**Responses to NRC RAIs on August 2013 Methodology
Transition LAR Submittal (Non-Proprietary)**

November 2016

WCNOC previously submitted a license amendment request (LAR) on August 13, 2013 (Reference 1) requesting approval of changes to the Wolf Creek Generating Station (WCGS) Technical Specifications (TSs). That application proposed the transition to Westinghouse core design and safety analysis methodologies, full scope implementation of Alternative Source Term (AST), and implementation of instrumentation setpoint and control uncertainty calculations based on the current Westinghouse Setpoint Methodology (including adoption of Option A of Technical Specification Task Force (TSTF) TSTF-493-A, Revision 4). WCNOC subsequently withdrew the LAR on June 18, 2014 (Reference 3) based on deficiencies discovered by WCNOC.

FIGURE 6.5-5

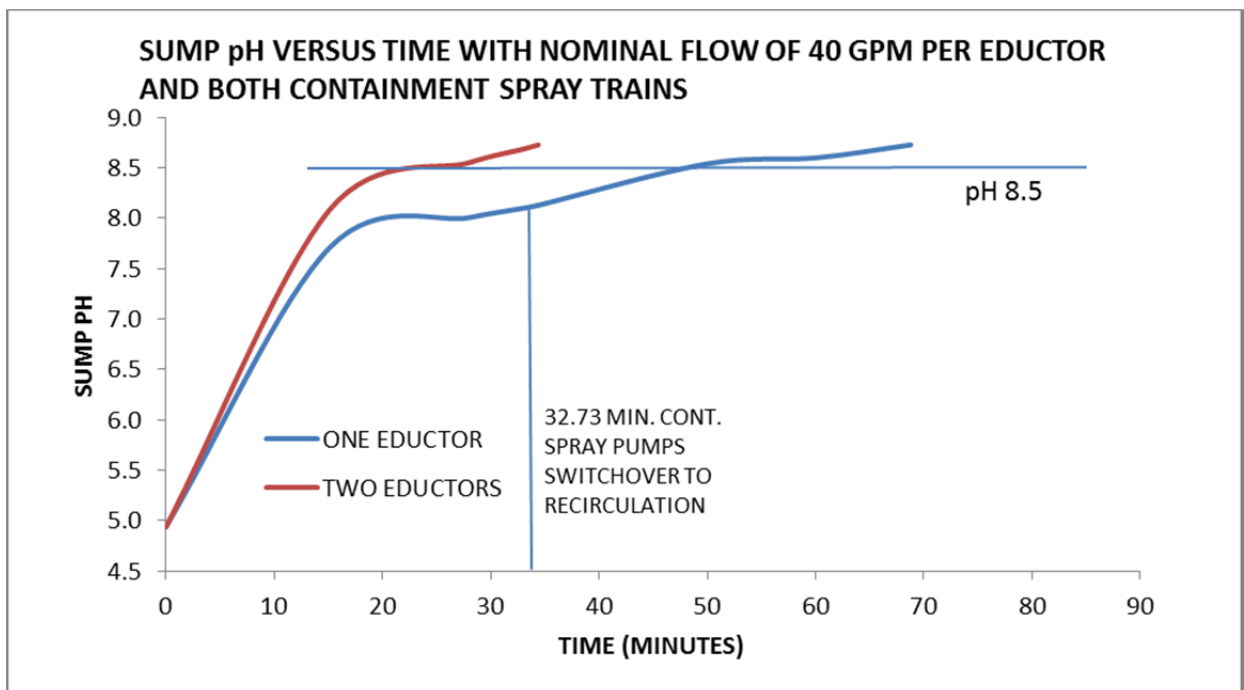
Describe the analysis methodology used to determine the pH in the sump water during the period of 30 days post-LOCA. Include detailed calculations of time dependent pH values in the sump during a 30 day period post-LOCA to demonstrate that the pH remains basic throughout this time period.

The figure below from the Wolf Creek USAR shows that the acceptance criteria of sump pH > 8.5 (minimum) is met for one or two containment spray eductors in service, considering also the generation of strong acids inside containment post-LOCA, consistent with the guidance of NUREG/CR-5950.

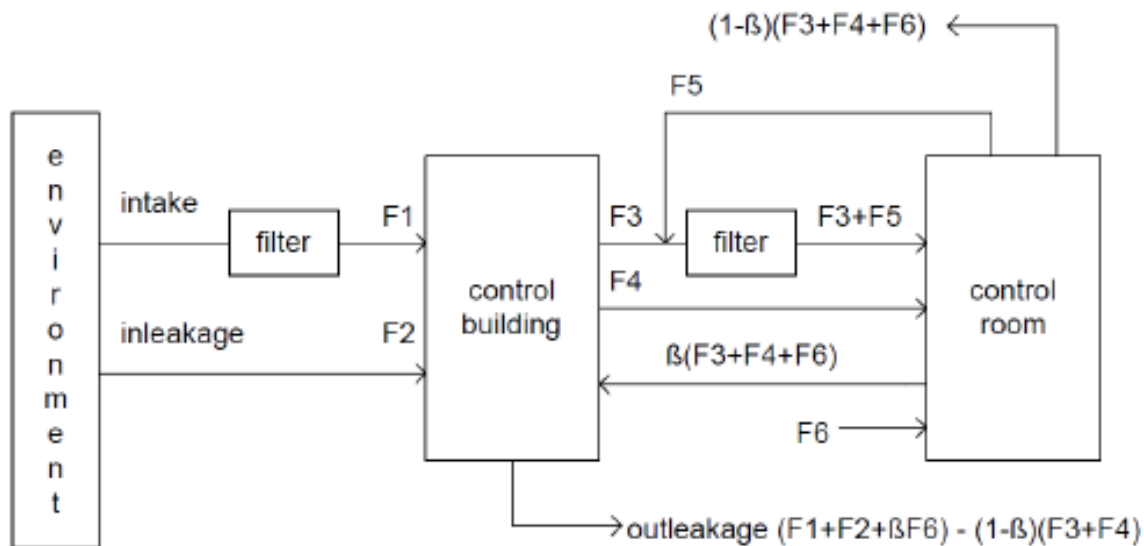
Please provide a diagram describing the model used for modeling the control building and control room for each design basis accident. Please provide the unfiltered in-leakage into the control building and justify the value. Please explain if this value has been confirmed by testing and if it will be confirmed periodically as part of a TS surveillance program. (Note this issue was previously identified in NRC Regulatory Issue Summary 2006-04, Issue Number 3.)

The figure displayed below (obtained from Section 15A.3 of the Wolf Creek USAR), provides a diagram of the flow rates modeled for the control building and control room. The "Normal Mode HVAC" flow rates are modeled prior to CREVS actuation. Following the CREVS actuation, the "Emergency Mode HVAC Prior to Operator Action" provides the flow rates considering a single failure of a control room filtration fan, which is consistent with the analysis of record single failure. The "Emergency Mode HVAC after Operator Action" flow rates are modeled after the failed train has been isolated by closing the train-specific damper.
